UNITED STATES PATENT AND TRADEMARK OFFICE

APPLICATION NO.	FILING DATE	FIRST NAMED INVENTOR	ATTORNEY DOCKET NO.	CONFIRMATION NO.
10/698,864	10/31/2003	Simon J. Lewis	15581.10.1	2003

Office Action Summary	Application No. 10/698,864	Applicant(s) LEWIS, SIMON J.	
	Examiner Jeremy Luks	Art Unit 2837

DETAILED ACTION

Figure A.

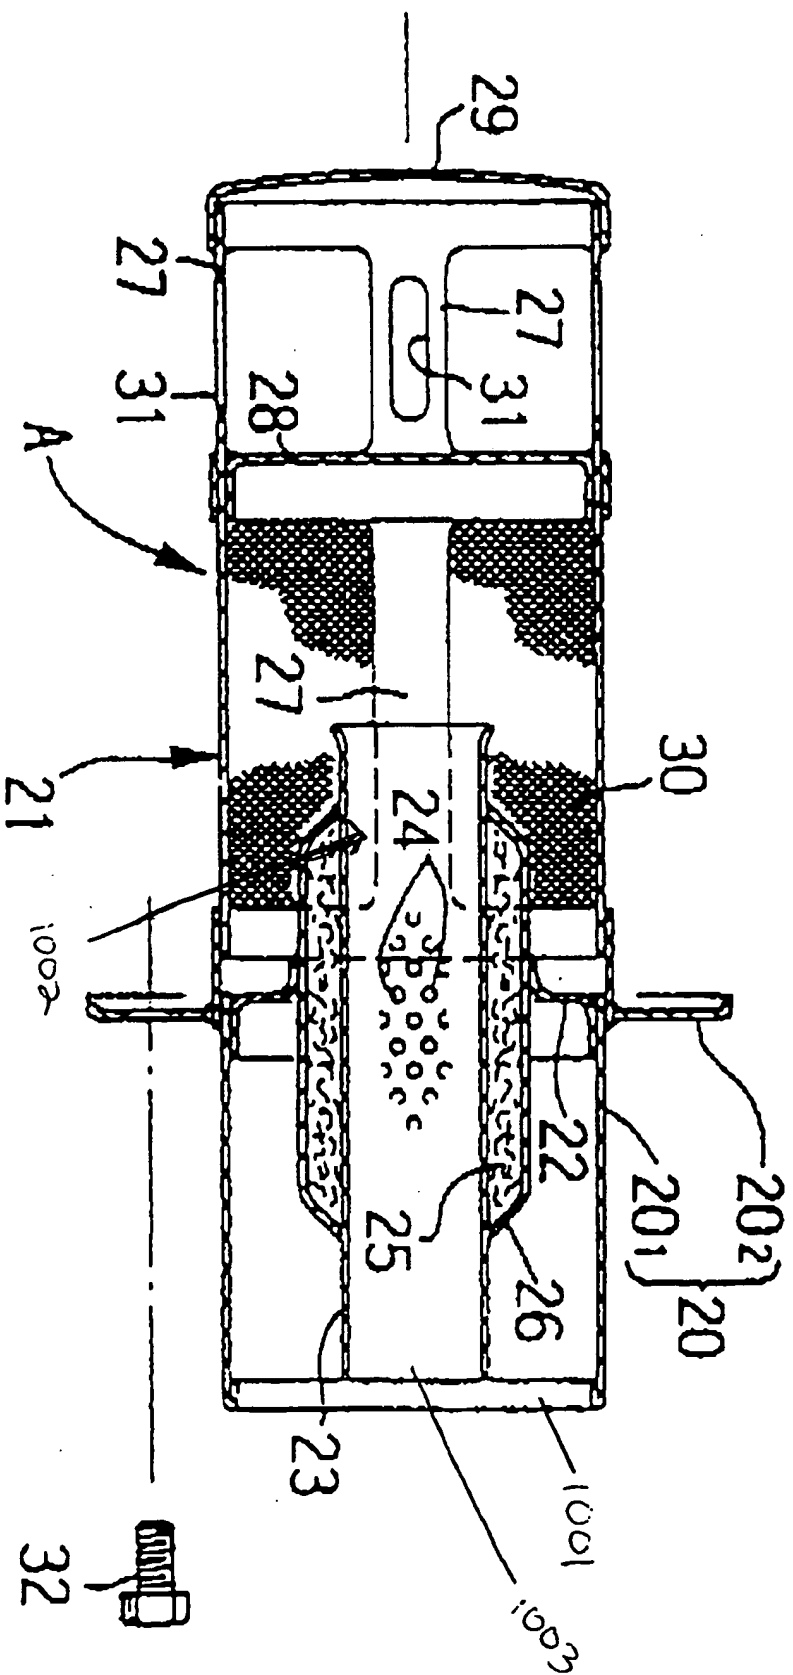
With respect to Claims 1, 2, 9 and 10 Yamaguchi teaches a tubular body (Figure 2, #2) having an interior surface (7) extending between a first end (5) and an opposing second end (11), the interior surface (7) bounding a chamber (C1-C3), an exhaust cap (13) disposed on the second end (11) of the tubular body (2), the exhaust cap (13) having an interior surface (12) bounding a channel (27) extending through the exhaust cap (13), the channel (27) being in communication with the chamber (C1-C3) of the body (2), an inlet cap (3) disposed on the first end (5) of the tubular body (2); a perf tube (24) longitudinally disposed within the chamber (C1-C3) of the tubular body (2); and a spark arrestor (Figure A, #A – See exploded view of spark arresting feature from Yamaguchi (5,969,299), Figure 5, provided by Examiner at the end of this Office Action)

With respect to Claims 12 and 22, Yamaguchi teaches a base (Figure A, #1001 – See exploded view of spark arresting feature from Yamaguchi (5,969,299), Figure 5, provided by Examiner at the end of this Office Action) comprising a tubular neck (23)

having a first end (1002) and an opposing second end (1003), the spark barrier (30) being mounted to the first end (1002) of the tubular neck (23) so that exhaust gas can pass through the spark barrier (30) and into the tubular neck (23).

With respect to Claim 40, Yamaguchi teaches a spark arrestor (Figure A, #A – See exploded view of spark arresting feature from Yamaguchi (5,969,299), Figure 5, provided by Examiner at the end of this Office Action) comprising a tubular neck (23) removably disposed (Col. 4, Lines 27-34) within the channel (27) of the end cap (13), the tubular neck (23) having a first end (1002) and an opposing second end (1003); and a spark barrier (30) mounted at the first end (1002) of the tubular neck so as to be at least partially disposed within the chamber (Figure 2, C1-C3) of the body (2), the spark barrier (30) being comprised of a sheet of mesh or porous material (Col. 4, Lines 20-22).
